## United States Patent and Trademark Office

, in	APPLICATION NO.		FILING DATE	FIRST NAMED INVENTOR	3	torney docket N	O. CONFIRMATION NO.
••••	10/704,086	********	11/07/2003	Cary E. Gloods	***************************************	12810-44107	3100
	35973	7590	08/14/2006		1	EX	XAMINER
	BINGHAN 2700 MAR		IALE LLP		***************************************		LE, STEPHEN M
	10 WEST N	11 1 1 1 1 1 1 1 1 1 1 1 1 1 1 1 1 1 1				ART UNIT	FAFER NUMBER
	INDIANAF	OUS,	IN 46204-4900			3753

#### RESPONSE TO OFFICE ACTION

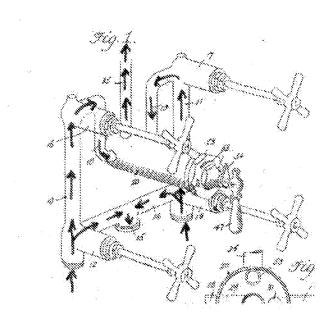
To the contrary, Weingarten '128 discloses a thermostatically controlled mixing valve that is coupled to primary hot and cold water supply pipes downstream of a pair each of hot and cold water control valves. As illustrated in FIG. 1 of Weingarten \*128, which is reproduced

below and has been annotated to facilitate this discussion, hot and cold water pipes 10, 11 receive water from hot and cold waters supplies at their lower ends. See Weingarten '128, Col. 1, line 55-Col. 2, line 2. Hot and cold water pipes 10, 11 are equipped with two pair of water control valves. Lower water control valves 12, 13 control the supply of hot and cold water to transverse mixing pipe 14 and upper water control valves 16, 17. Upper water control valves 16, 17 (as well as lower water control valves 12, 13) control the hot and cold water supply to feed pipes 18, 19, which feed into temperature regulating device 20. Fig. 5 of Weingarten '128 also illustrates a mixing valve 66 coupled to water supply pipes 60, 61 downstream of manually actuated valves 62, 63, which control the supply of hot and cold water to the mixing valve 66. Accordingly, Weingarten '128 fails to disclose, teach or suggest a thermostatic mixing valve system coupled to hot and cold water supply pipes at a location upstream of the hot and cold water control valves.

Furthermore, contrary to claim 1, because the mixing valve system of Weingarten '128 is connected to the primary hot and cold water supply pipes downstream of hot and cold water control valves 16, 17 and 12, 13, the mixing valve 20 of Weingarten '128 is incapable of controlling the flow of water to the hand held shower head independent of and exclusive of the hot and cold water control valves.
